NO.1 TRITON SQUARE

NMA DESIGN REPORT

246868-A_A-XX-XX-DR-AX-30510 North Elevation

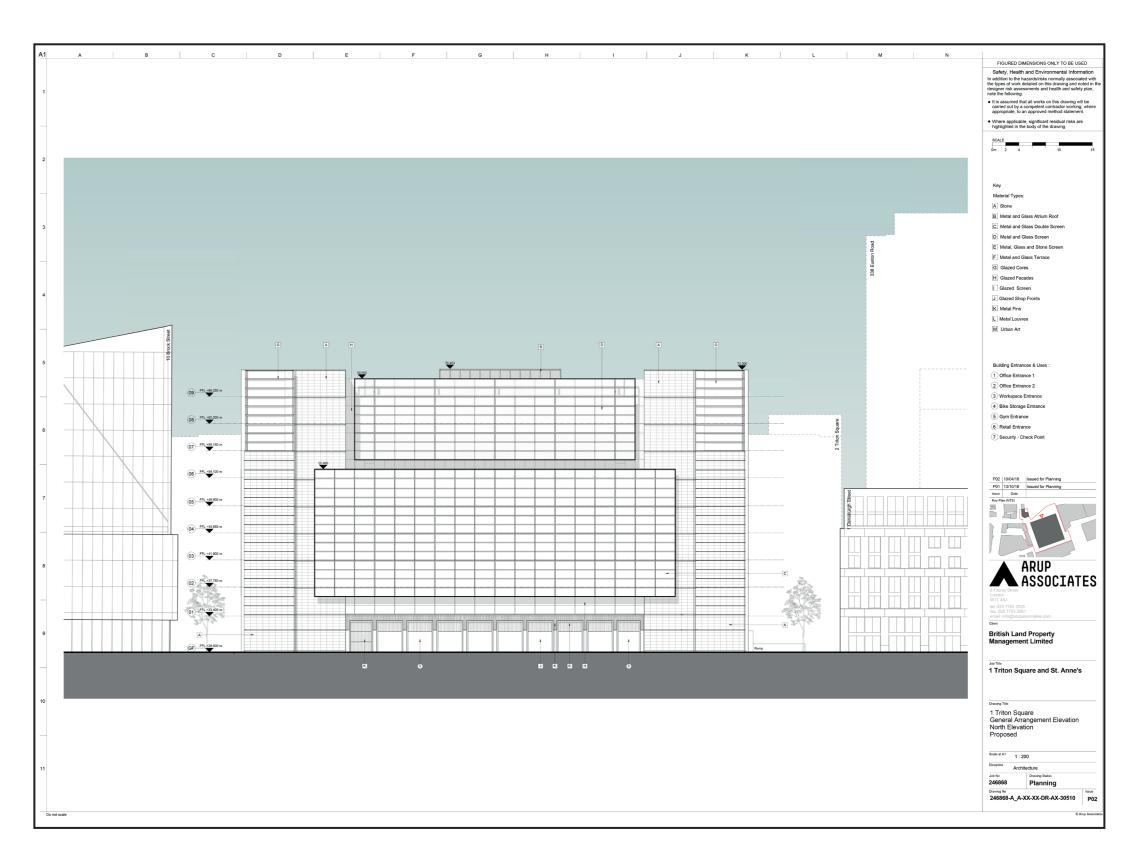
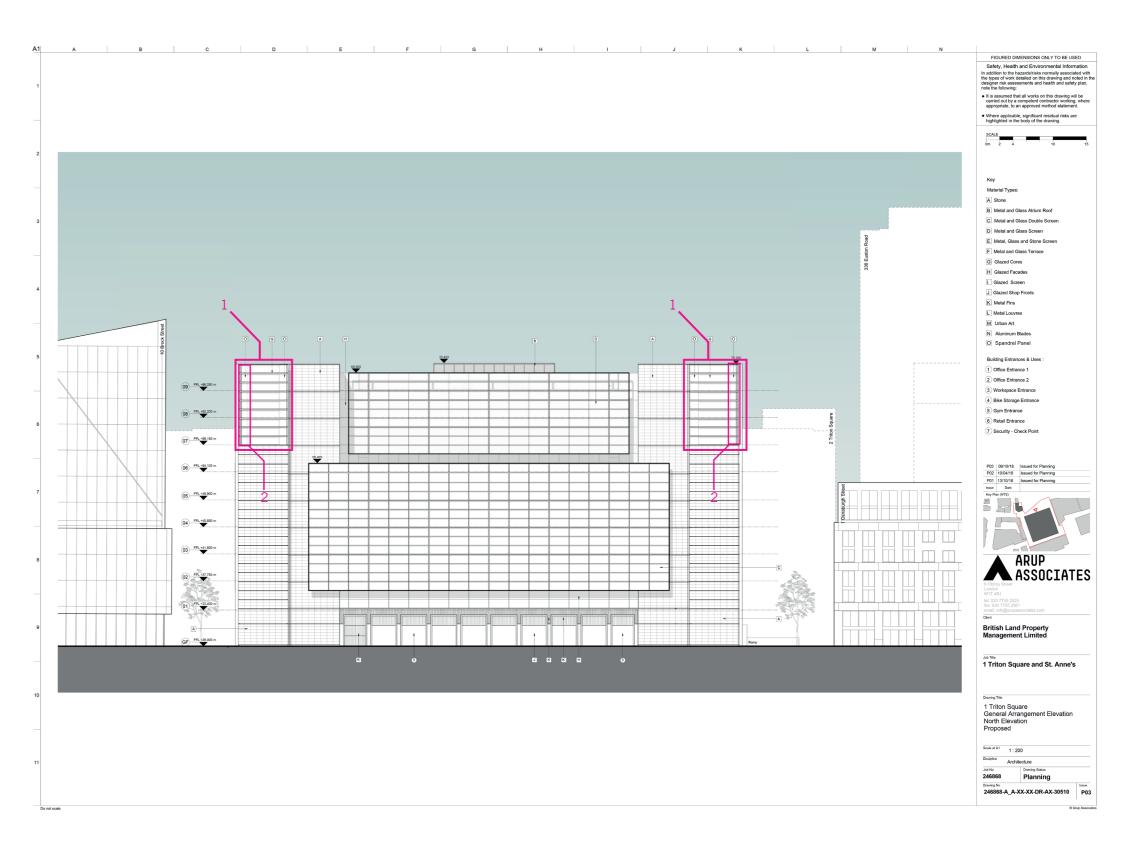
- (1) A change in materials to the transoms at the top of cores from stone to anodised aluminium is proposed. Each transom is 7m wide and following design development deemed structurally unachievable given weight and aesthetic requirement for unobstructed panoramic glazing panels. This affects 6 of the 10 transoms at the top of each core. The remaining 4 are natural anodised aluminium as approved.
- (2) Introduction of additional mullion to separate back painted glass spandrel panel from vision glazing note spandrel panel hides steel column behind.
